Memorandum

Subject: Robert J. Keogh & Lisa A. Keogh – Variance Application
8806 Landis Avenue
Block: 89.03 Lots: 44.02 & 45
R-2 Two Family Residential Zoning District
City of Sea Isle City, Cape May County, New Jersey

Project No.: SIZ0287

SIDEWALK DETAIL
N.T.S.

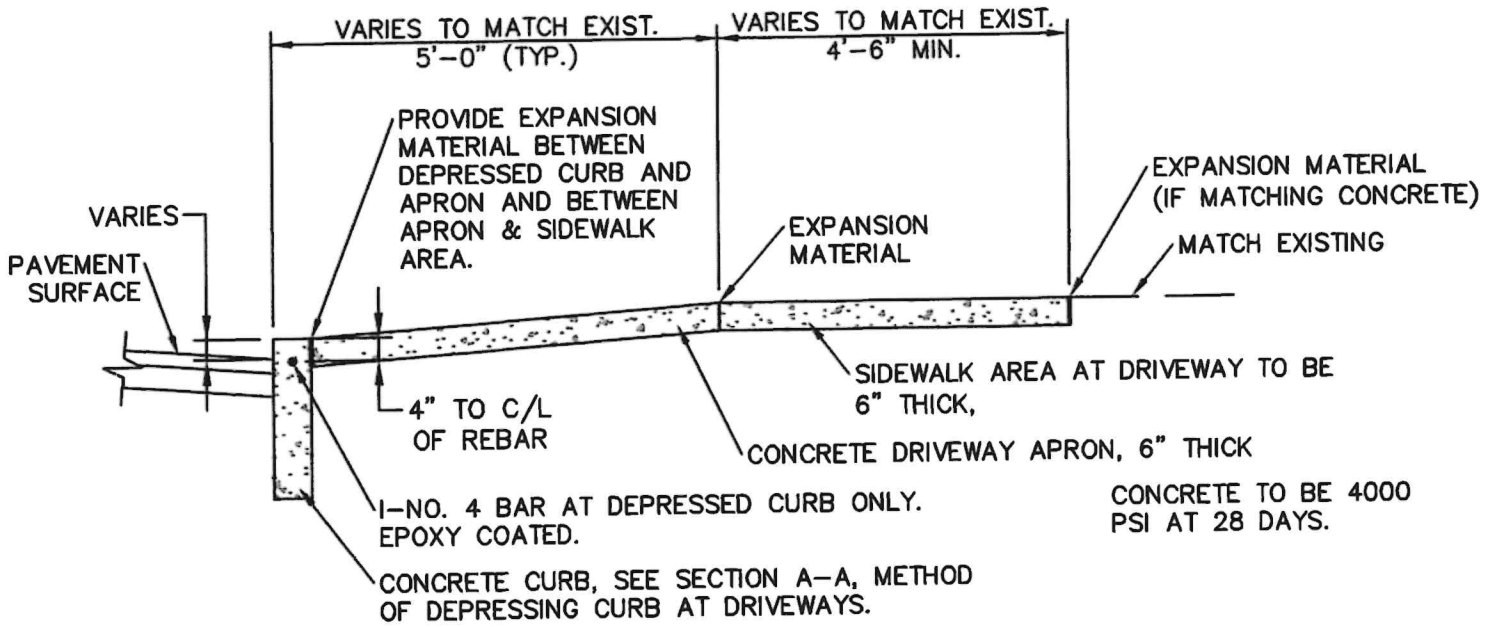
8. The plot plan includes concrete apron detail and sidewalk details however these details are not the City standards. I will provide the design engineer with the City standards for driveways and sidewalk areas.
